ONS-2016-037

Subject: Response to Request for Additional Information (RAI) for Relief Request 14-ON-001,  
Letdown Cooler Nozzle Welds (CAC NOS. MF6290, MF6291 AND MF6292)  
(ADAMS Accession No. ML16061A565)

**Oconee Nuclear Station Unit 1, 2 and 3,  
Response to Request for Additional Information (RAI), regarding  
Relief Request 14-ON-001 for Letdown Cooler Nozzle Welds**

**Sketch 1**

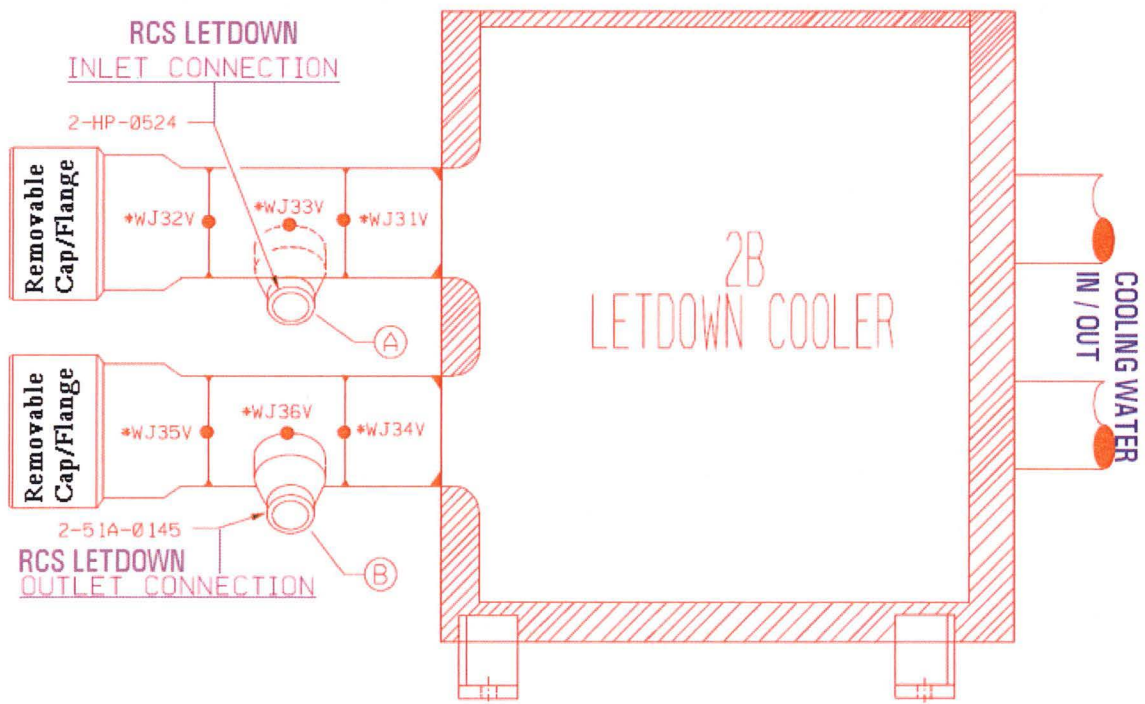
*Please provide a more detailed description of the nozzle inside radius sections that are required to be ultrasonically examined per the ASME Code, Section XI, by either referring to the drawings in the relief request as a guide or by providing additional sketches or drawings of the subject welds/nozzles.*

The welds WJ33V and WJ36V in Sketch 1 below represent the typical nozzle to cooler welds for all letdown coolers and all units. These welds are inspected per ASME Section XI, Table IWB-2500-1, Exam Category B-D, Item No. B3.150 and are not within the scope of this relief request.

This relief request only applies to inspections for Item B3.160 exams of the inner radius section of the nozzle base material (see Sketch 2 below).

Sketch 2

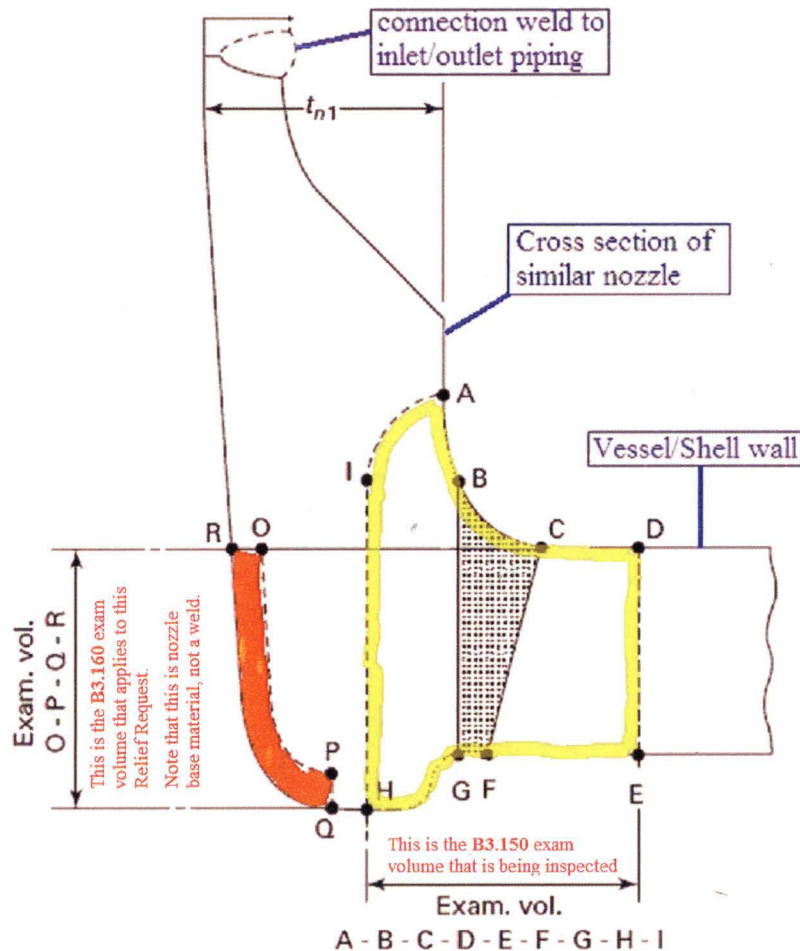
***Section 1 of the relief request states that "...Oconee Unit 1 has two Letdown Coolers 1A and 1B. Each component has typically four B3.160 welds..." Please confirm that the required examination is on the attachment welds of the nozzles, not the nozzles themselves, and that the required examination is on the inside radius of the welds.***

***It appears that the nozzles are forged and are attached to the side of a pipe as a branch connection. The welds are deposited on the inside and outside circumference of the nozzles that are attaching to the pipe. Is the staff's understanding correct? If not, please clarify.***

The exam volumes for Category B-D, Items B3.150 and B3.160 are illustrated below (Reference ASME Section XI, Figure IWB-2500-7(a)). Relief Request 14-ON-001 only applies to the exam of Item B3.160, which is the inner radius section (base material). The B3.160 exam volume is adjacent to the B3.150 weld exam volume, but is not a weld exam. (see sketch OM-201.-3276.001, Detail "A" in the relief request.)

As stated and illustrated in RAI 1 above, the Relief Request is limited to the B3.160 exam volume only, which is the nozzle "inner radius" section (i.e., base material). The nozzle-to-cooler weld is inspected as an Item B3.150 exam. Relief is not being requested for the B3.150 exams.

Referring to the nozzle inner radius section (Item B3.160) as locations rather than welds in the original request would have been clearer, but this relief request only applies to the inner radius of the nozzle base material illustrated in RAI #1 as exam volume O-P-Q-R.
